SECTION 00 9112
ADDENDUM NUMBER 2

DATE: 03/02/2021
PROJECT: CITY OF MILLERSBURG FIRE STATION 15
ARCHITECT'S PROJECT NUMBER: 20006
OWNER: CITY OF MILLERSBURG
ARCHITECT: SODERSTROM ARCHITECTS

6 EAVE @ WOOD ROOF
3" = 1'-0"

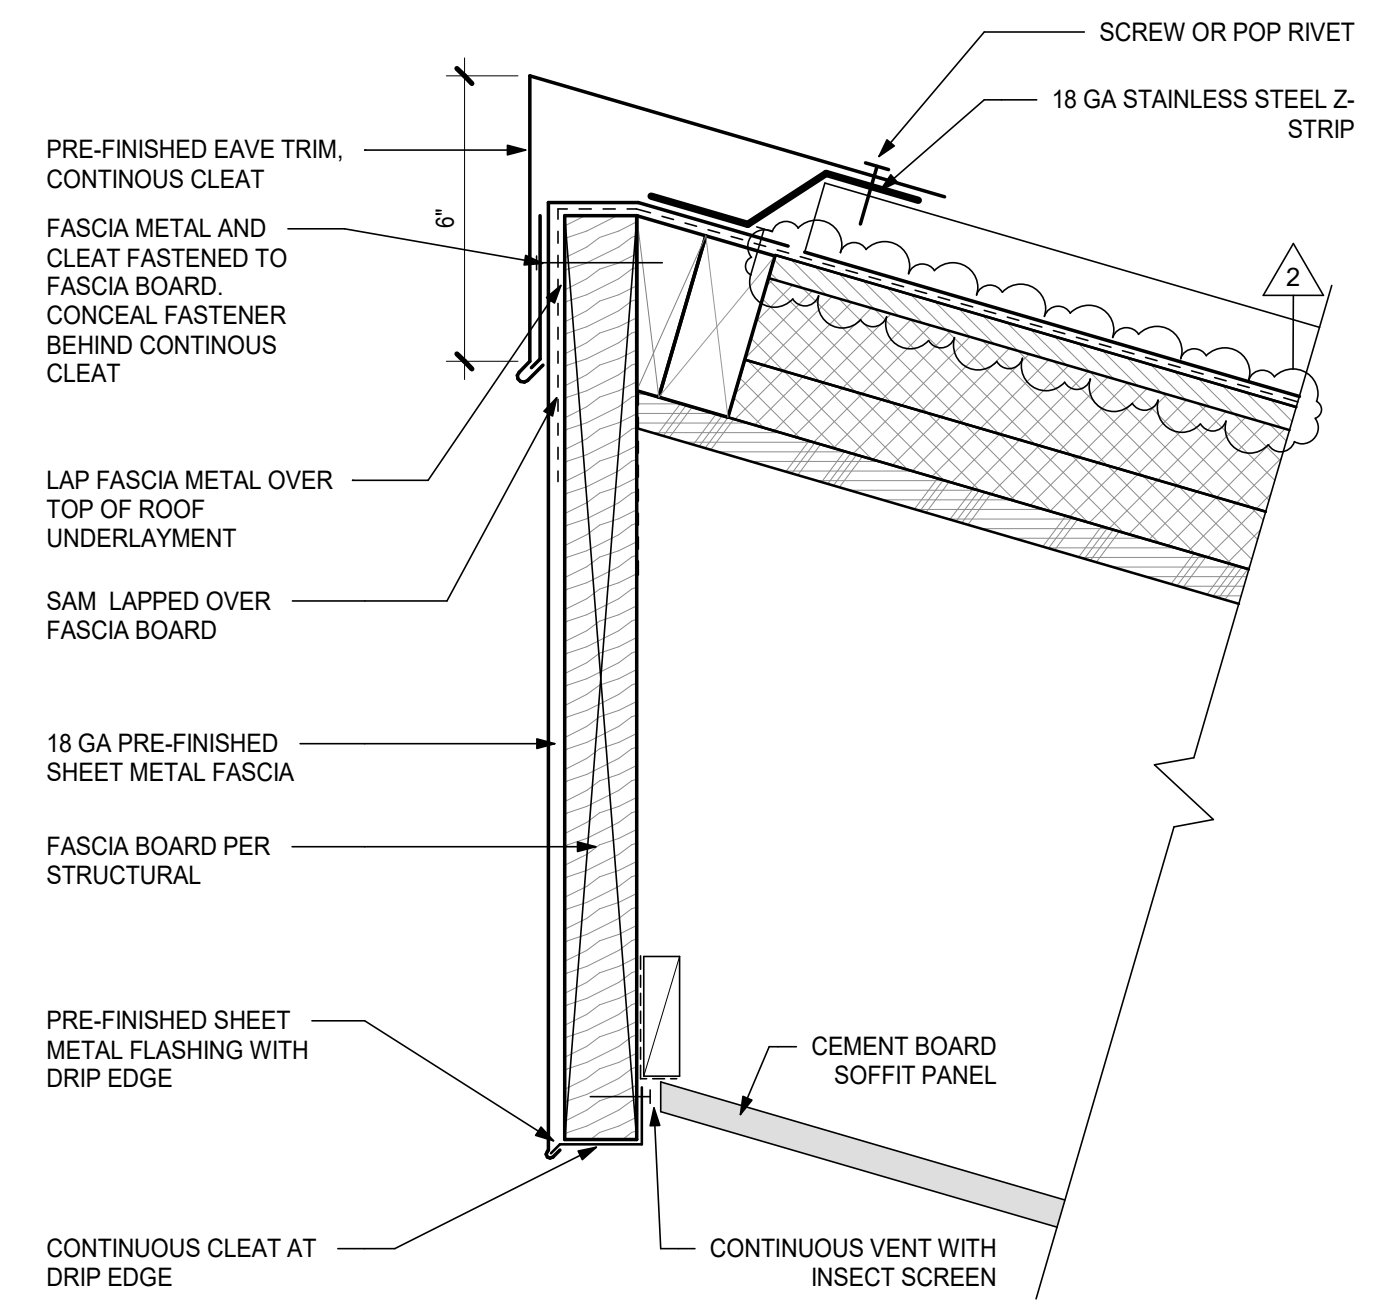
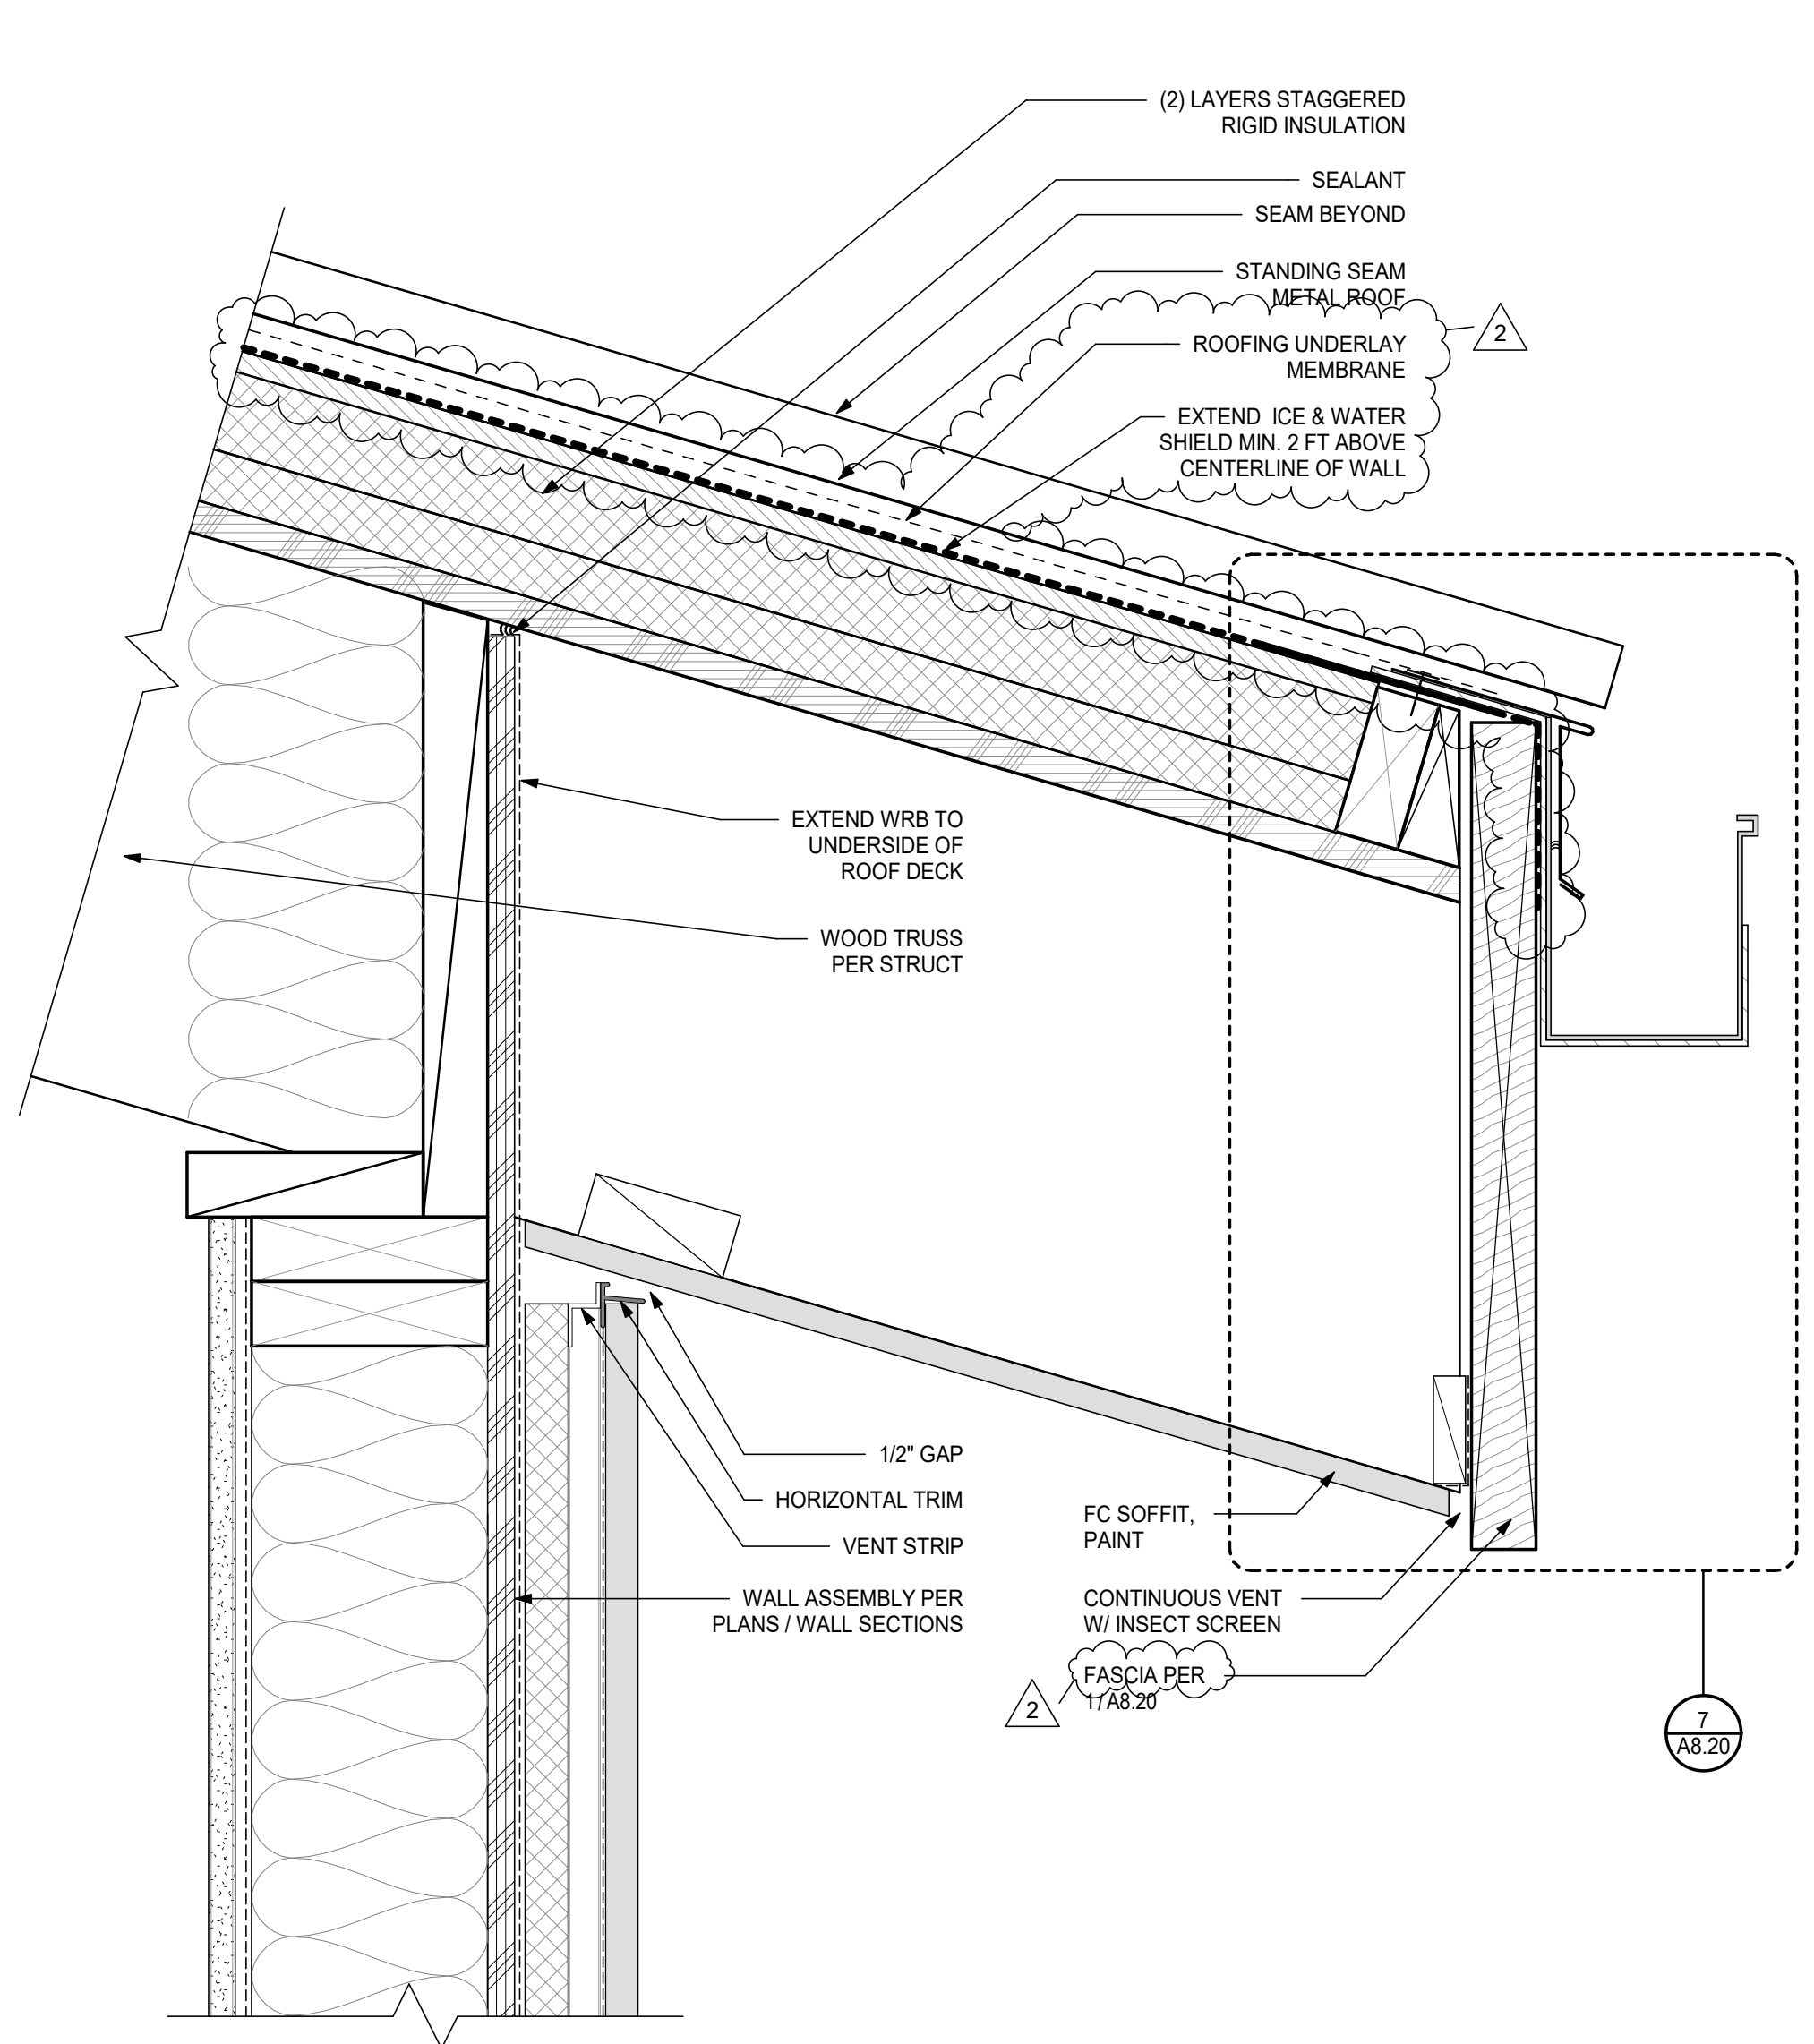
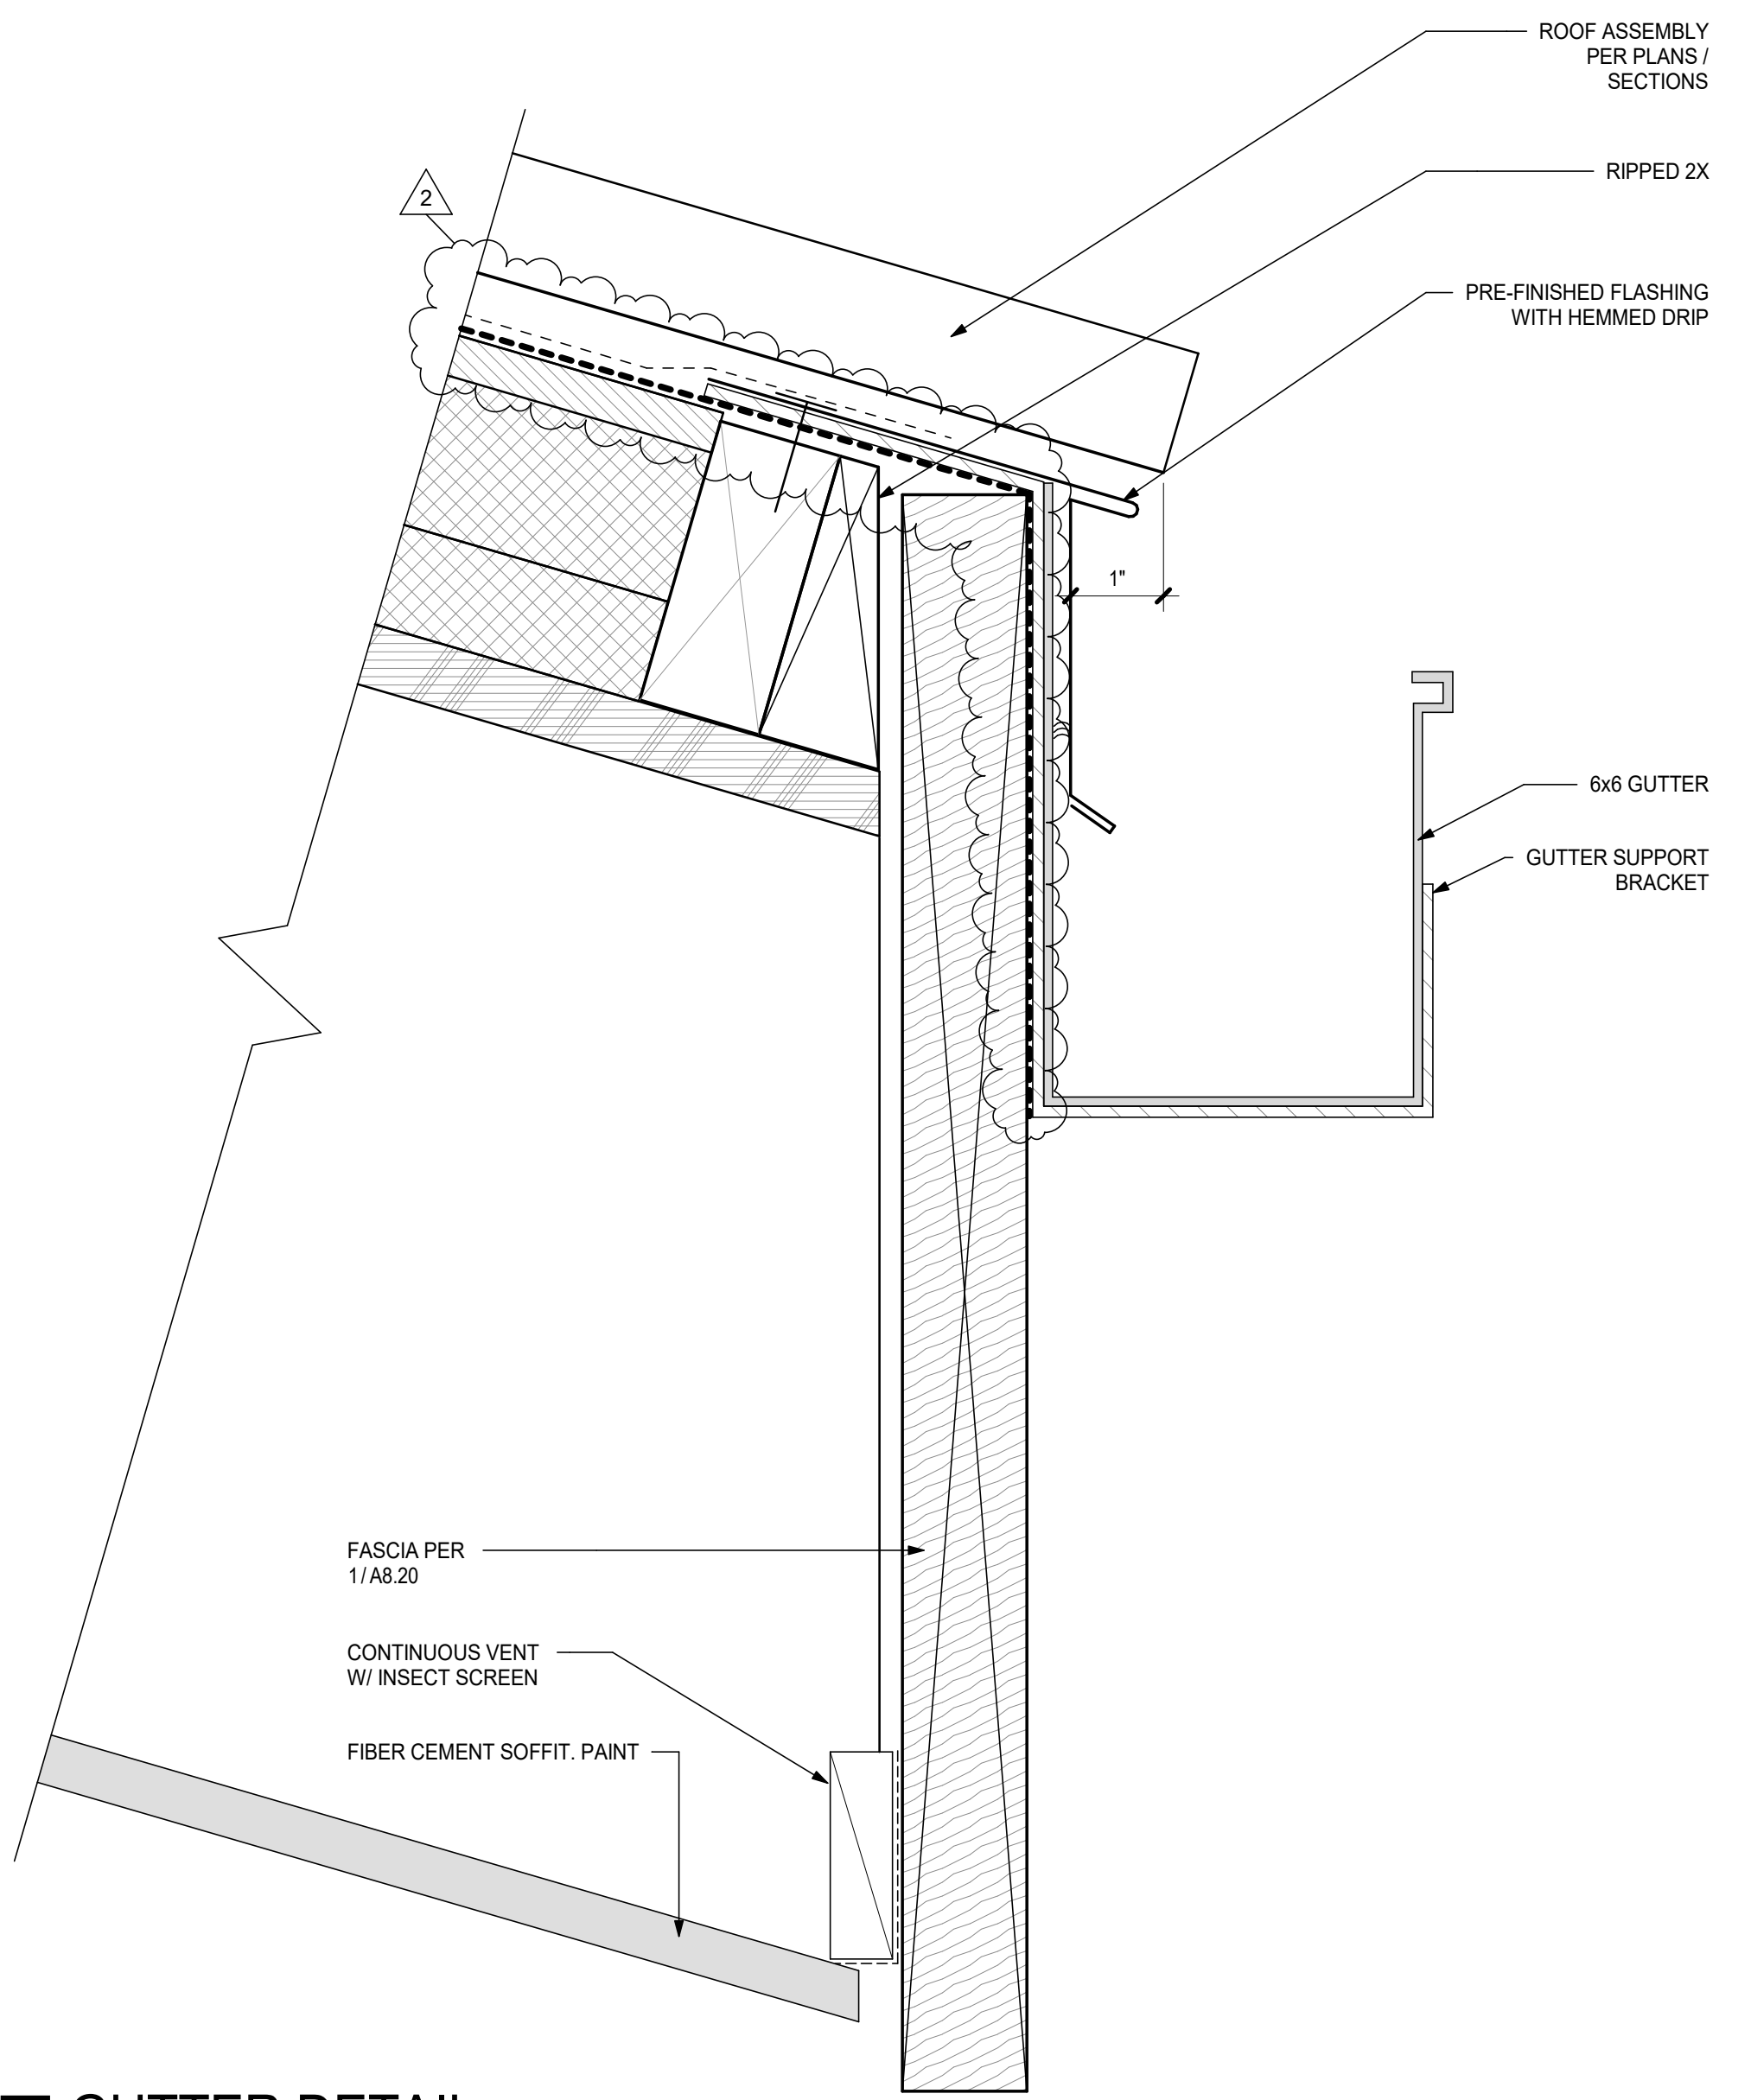
DRAWING A8.20

Revise Details 1, 5, 6, 7, 9, and 10 to show coverboard at insulation

Revise Details 6 and 7 to indicate underlayment lapped over Ice & Water Shield

Revise Detail 6 to remove reference to cedar fascia

- A. A 20" high LSL board will be used for fascia board at all locations. See revised details on A8.20 and revised Keynote 3004 on A3.01 and A3.02, reissued with this addendum.

- A. A cover board has been added to the roof assembly to allow for adherence of underlayment and ice and water shield. See revised A0.01 and A8.20 reissued with this addendum.
